SUBDIVISION COMMITTEE
METROPOLITAN AREA PLANNING COMMISSION

STAFF REPORT
(Final Plat)

CASE NUMBER: S/D 92-20 SCHOFIELD-HATCHETT 3RD ADDITION

VICINITY MAP:

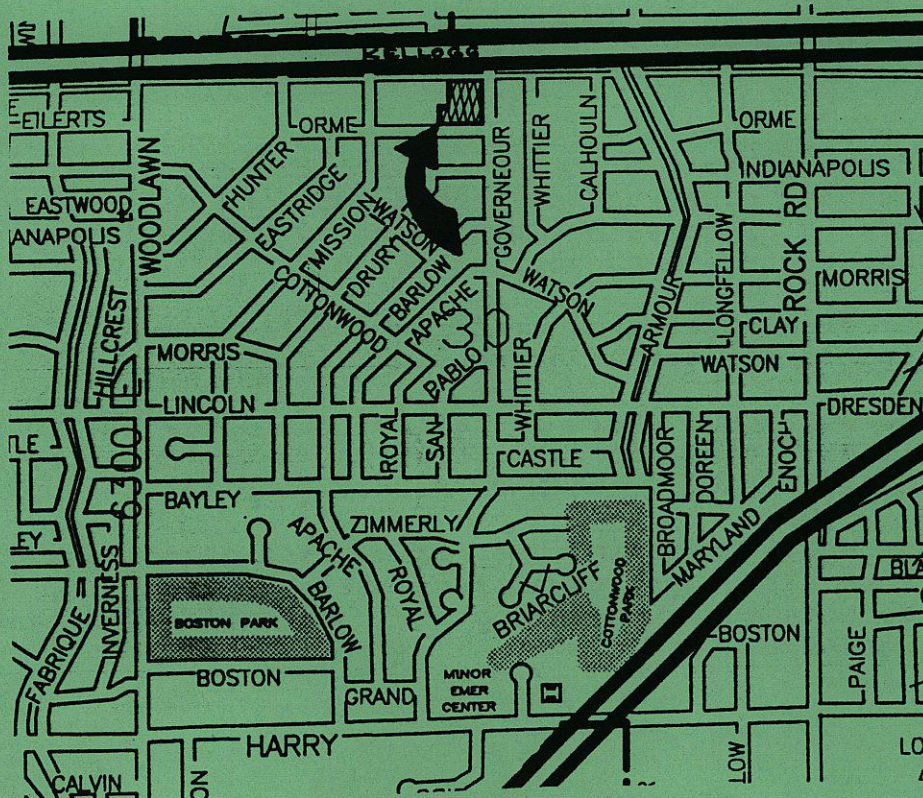
- A. When the zone change for a portion of this site was approved, the applicant agreed to provide a plan and landscaping adjacent to Orme. The applicant shall either prior to the release of the plat for recording complete the landscaping as indicated on the submitted plan or provide a fiscal guarantee for the landscaping.

- B. When the original Schofield-Hatchett Addition was approved, the applicant agreed, as required by the sidewalk ordinance to install sidewalk along the plat adjacent to Gouverneur. A sidewalk certificate was subsequently submitted with this plat. However, this sidewalk has apparently not been installed. Consequently, the applicant shall install this sidewalk before the release of the plat for recording or a fiscal guarantee shall be submitted for the sidewalk's installation.

- C. The area of the zone change involved two existing homes, with driveways out to Orme. This area is now being platted with complete access control. If these drives have not been closed, a guarantee shall be submitted for the closure of these drives.

- D. On the final plat tracing the recording information for the drainage easement shall be indicated.
 - E. The applicant shall submit an avigational easement covering all of the subject plat and a restrictive covenant assuring that adequate construction methods will be used to minimize the effects of noise pollution in any habitable structures constructed on subject property.

- F. The final plat shall reference a tie point to a previously platted lot corner or section corner.
 - G. The applicant shall install or guarantee the installation of all utilities and facilities which are applicable and described in Article 8 of the MAPC Subdivision Regulations.

- I. Perimeter closure computations shall be submitted with the final plat tracing. Section 5-101(c).
- J. Recording of the plat within 30 days after approval by the City Council.
- K. The representative from City Engineering should be prepared to comment on the status of the applicant's drainage concept.
